## PUBLIC UTILITIES COMMISSION

SA2024-1232

**SUBJECT:** Facilities Audit of PacifiCorp's Klamath Falls Substations

**PACIFICORP, KLAMATH FALL HEADQUARTERS  
SUBSTATION AUDIT FINDINGS  
AUGUST 12-16, 2024**

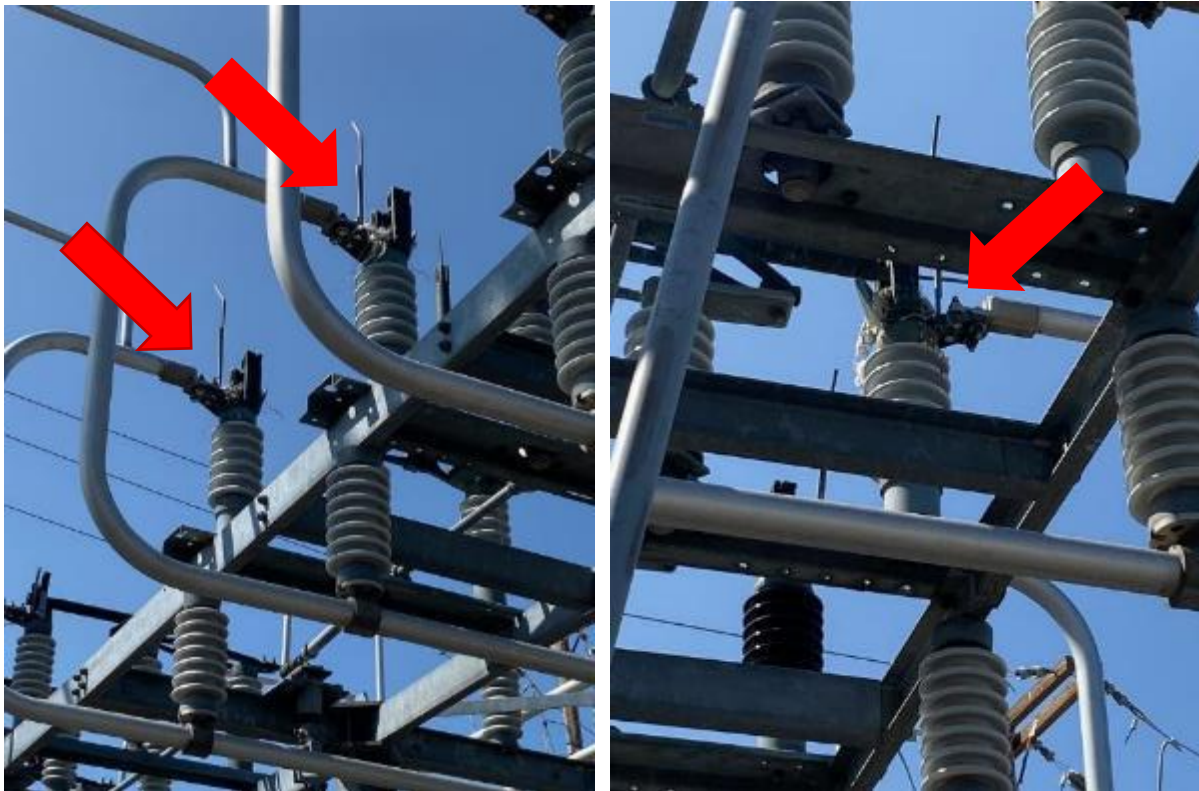
1.2. Station fence has an unattached ground wire.

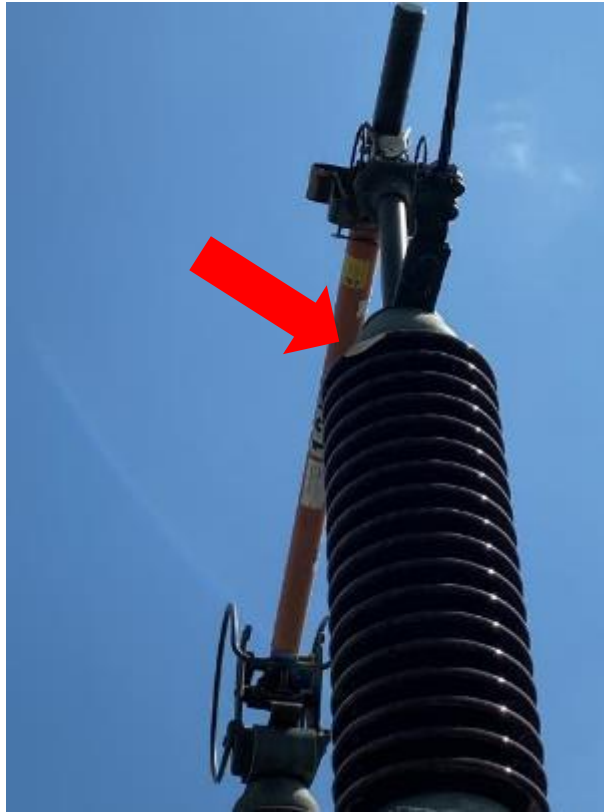
7.4. Circuit breaker 3L25 has chips on three bushing insulators.
